## ADDENDUM NO. 2

Date: December 9, 2010  
To: Short-Listed Contractors  
From: Darrell Hunting– Project Manager  
Reference: New Ogden Driver License Building  
Department of Public Safety – Ogden, Utah  
DFCM Project No. 10052550  
Subject: **Addendum No. 2**

## Addendum No. 2

PROJECT: Ogden Driver License Building Replacement  
 South Ogden, Utah  
 DFCM Project Number: 10052550

A4 WALL SECTION  
 AE355 SCALE 1" = N.T.S.

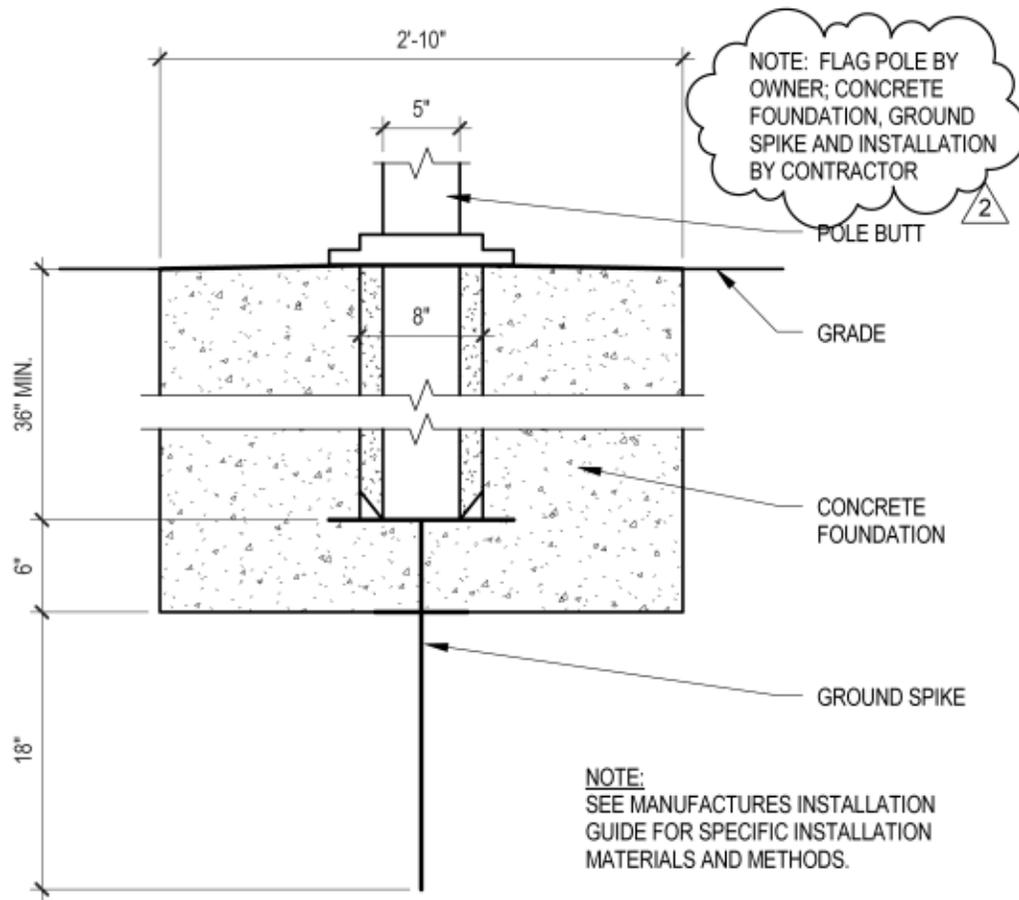
2-81	AE354	Add General Note 3. as follows: "3. PROVIDE AND INSTALL 6 INCH THICK FREE DRAINING GRAVEL BELOW ALL INTERIOR CONCRETE SLABS."
2-82	AE355	A3/AE355, A4/AE355, A5/AE355; Change Note: "1 1/2 INCH RIGID INSULATION" to "2 INCH RIGID INSULATION"
2-83	AE355	Add General Note 3. as follows: "3. PROVIDE AND INSTALL 6 INCH THICK FREE DRAINING GRAVEL BELOW ALL INTERIOR CONCRETE SLABS."
2-84	AE355	A4/AE355; Replace A4/AE355 with revised A4/AE355 as per attachment AD2-4.
2-85	AE356	Add General Note 3. as follows: "3. PROVIDE AND INSTALL 6 INCH THICK FREE DRAINING GRAVEL BELOW ALL INTERIOR CONCRETE SLABS."
2-86	AE356	A3/AE356; Change Note: "1 1/2 INCH RIGID INSULATION" to "2 INCH RIGID INSULATION"
2-87	AE356	A3/AE356; Change Note: "1 INCH FIBER BOARD INSULATION" to "1 INCH GLASS FIBER BOARD INSULATION"
2-88	AE401	A3/AE401; Replace A3/AE401 with revised A3/AE401 as per attachment AD2-6.
2-89	AE501	C1/AE501; Replace C1/AE501 with revised C1/AE501 as per attachment AD2-2.

A3  
AE501

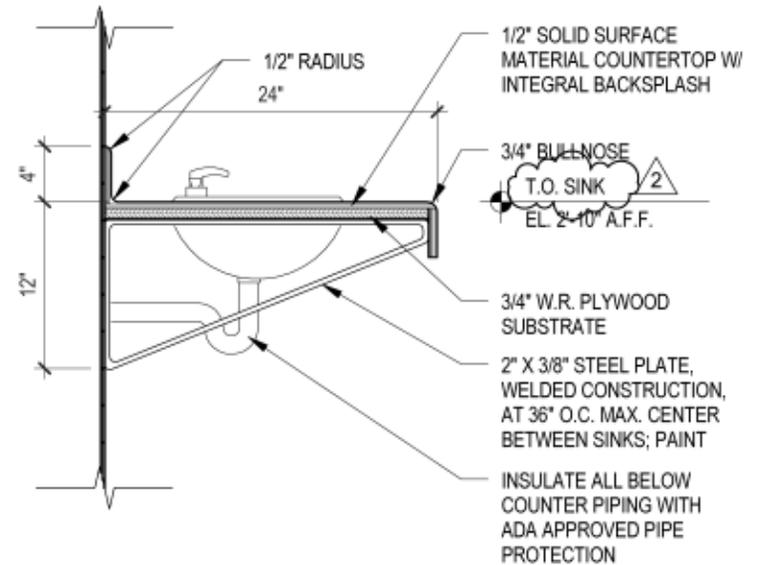
2-90	AE501	A3/AE501; Replace A3/AE501 with revised A3/AE501 as per attachment AD2-5.
2-91	AE521	Change Detail Reference 1/AE521 to B3/AE521.
2-92	AE571	A1/AE571; Replace A1/AE571 with revised A1/AE571 as per attachment AD2-5.
2-93	AE591	Add detail D5/AE591 as per attachment AD2-3.
2-94	AE601	DOOR AND FRAME SCHEDULE; change HEAD and JAMB DETAILS from A2 to D5 for the following doors: 120A, 121A, 122A, 123A, 124A, 125A, 127A, 128A, 129A.

**SK005**

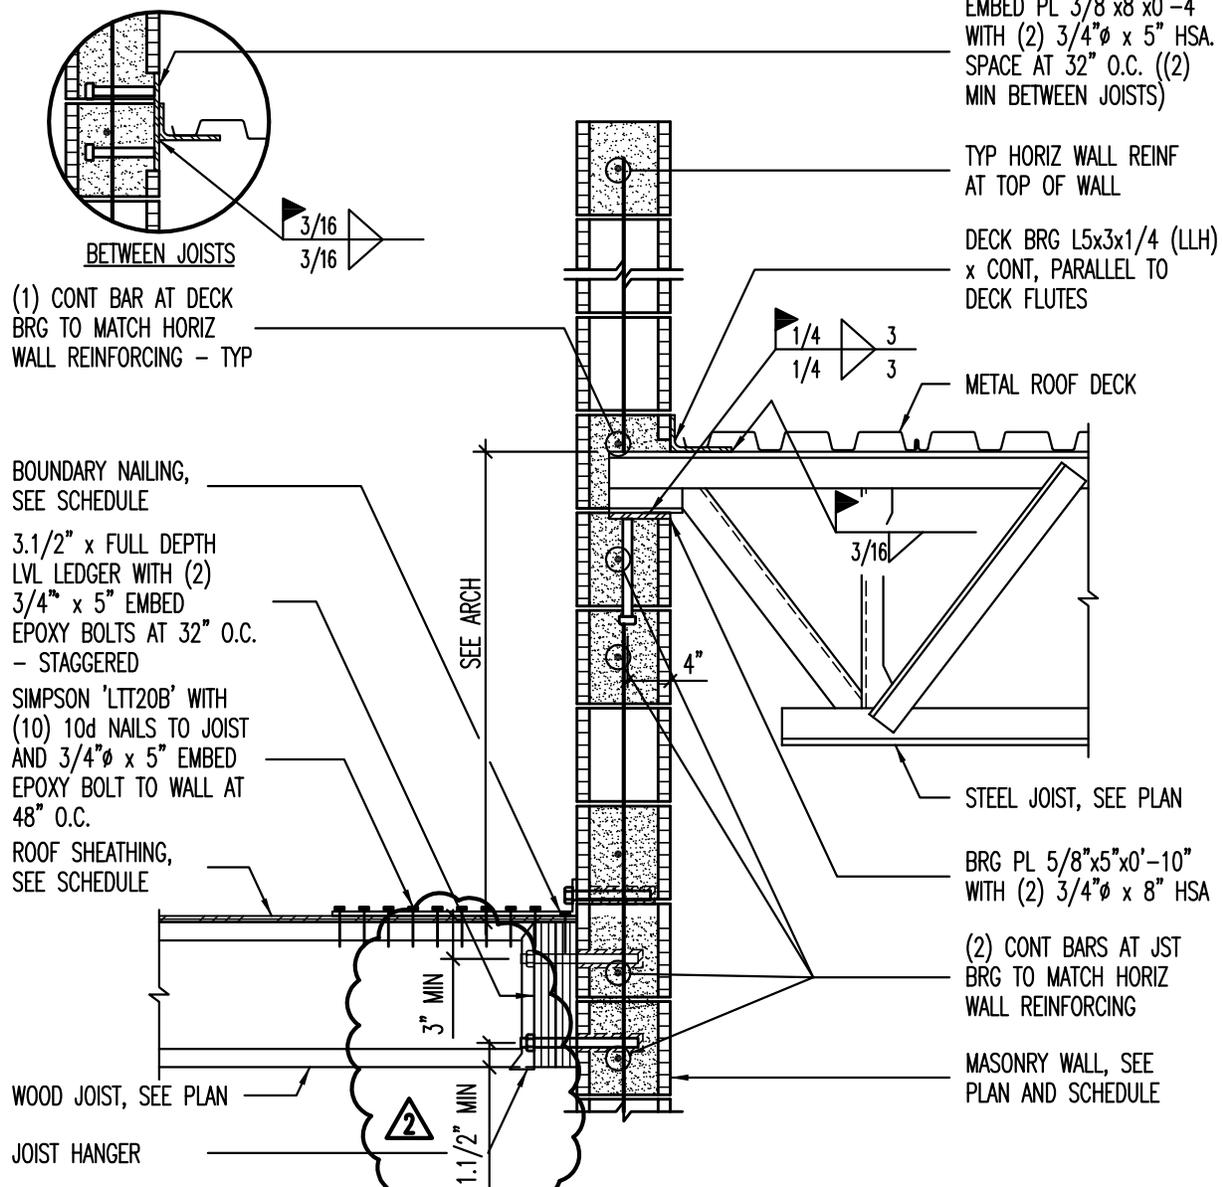
- 2-98 S511 Replace 9/S511 with revised detail 9/S511 as per attachment SK005. NOTE: THE REVISIONS TO DETAIL 9/S511 ALSO PERTAIN TO DETAILS 9, 10, 11, 12 AND 13 ON SHEET S511.

**SK007**

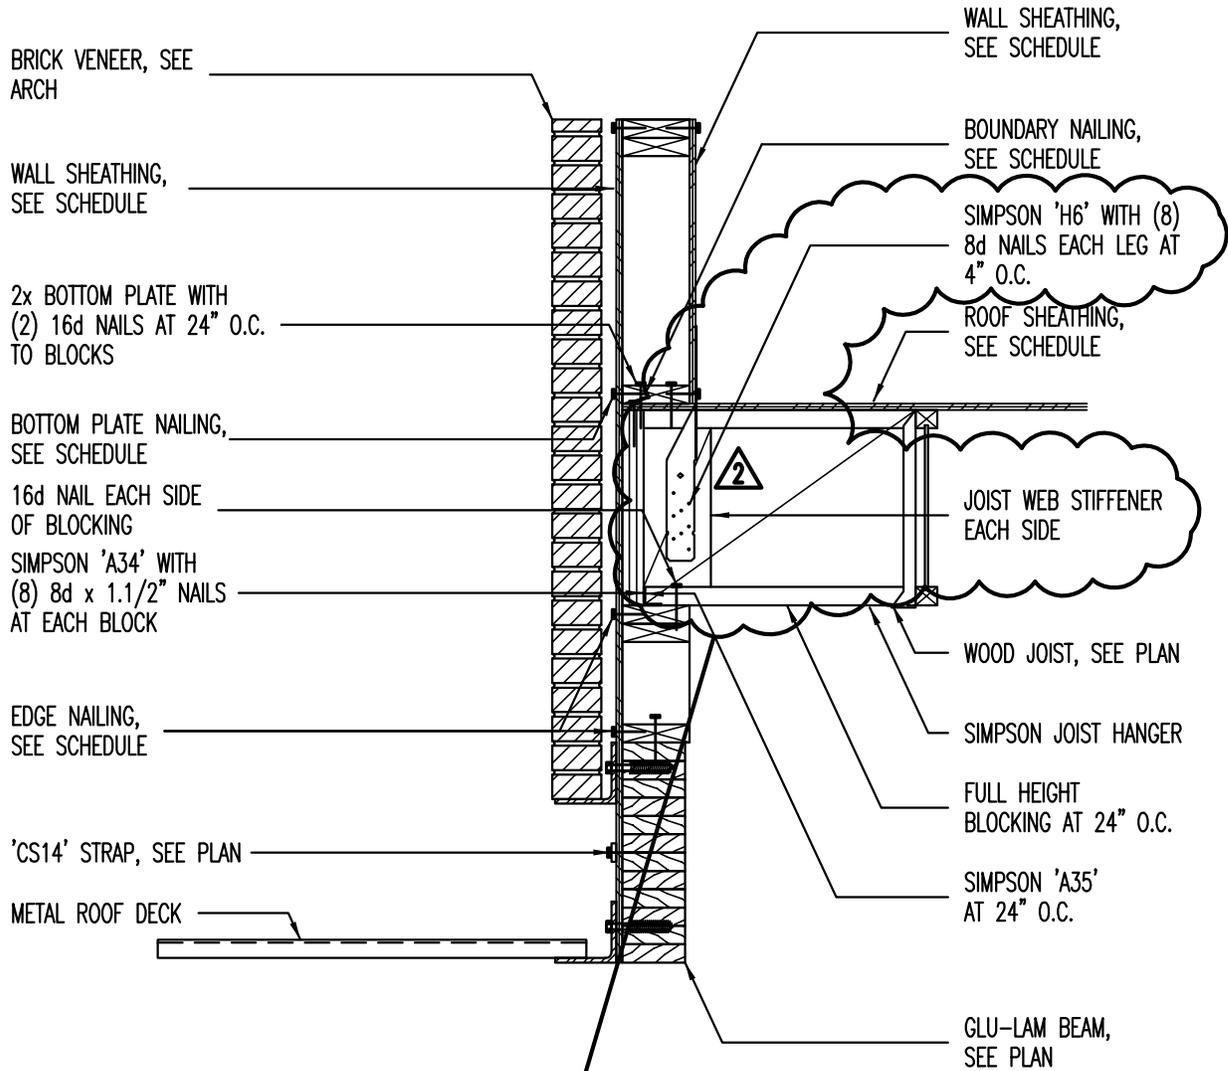
- 2-100 S513 Replace 6/S513 with revised detail 6/S513 as per attachment SK007. NOTE THE REVISIONS TO DETAIL 6/S513 ALSO PERTAIN TO DETAILS 6, 9, 10, 11, 13 AND 15 ON SHEET S513.

**ELECTRICAL SITE PLAN**  
SCALE = 1" = 20'-0"

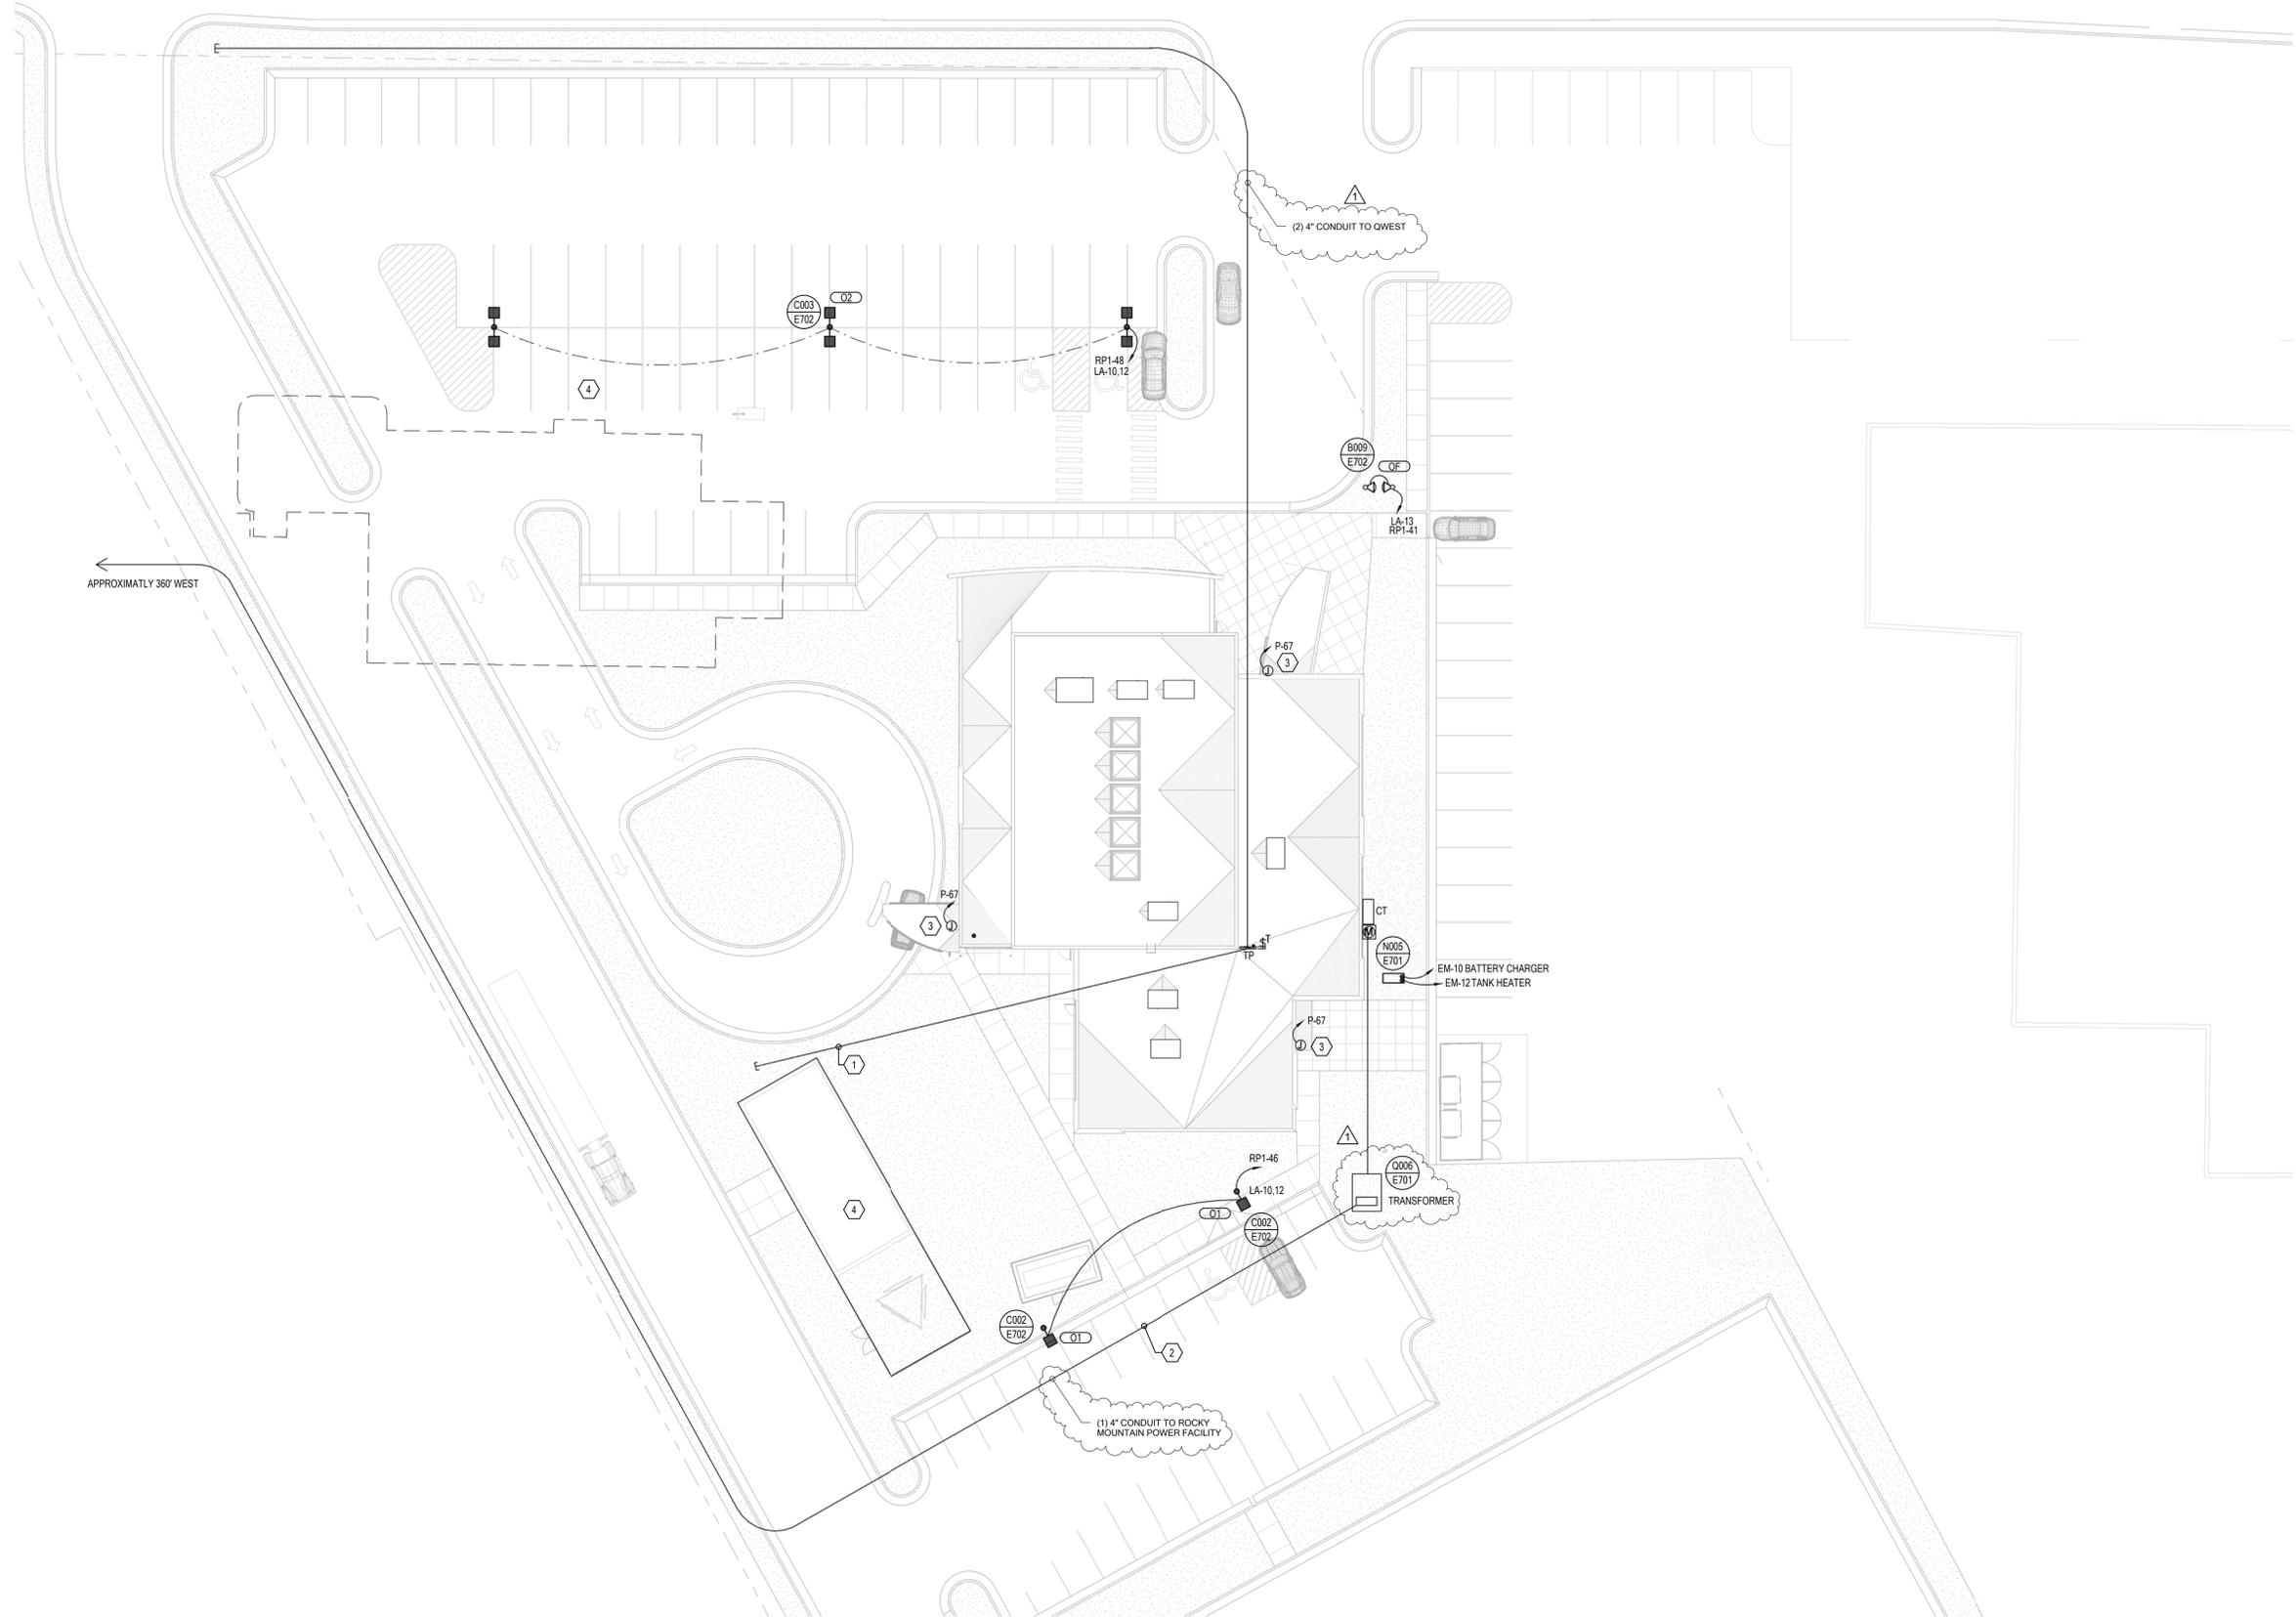
- 2-102 E101
1. Provide (2) 4” conduits from the new building telephone panel to the Qwest facilities in the road north of the existing Drivers License Building per attached revised Electrical Site Plan. Use wide sweep elbows. Provide pull rope. Coordinate exact location with the General Contractor after Blue Stake marking is completed. Qwest contact is Gary Weaver (801) 626-5380.

2. Provide (1) 4” conduit from the new transformer pad to a new pad mounted sectionalizer cabinet, and from the sectionalizer cabinet to the existing sectionalizer cabinet located approximately 360’ west of the existing Drivers License building transformer. Provide a concrete sectionalizer pad per Rocky Mountain Power requirements and coordinate exact location with Rocky Mountain Power. Provide trenching, backfilling and asphalt repair as required. Rocky Mountain Power contact is Craig Garner (801) 629-4432.

3. See attached Pacificop Map showing approximate location of existing sectionalizer cabinet referred to in note 2 above.
  4. See attached revised Sheet E101:
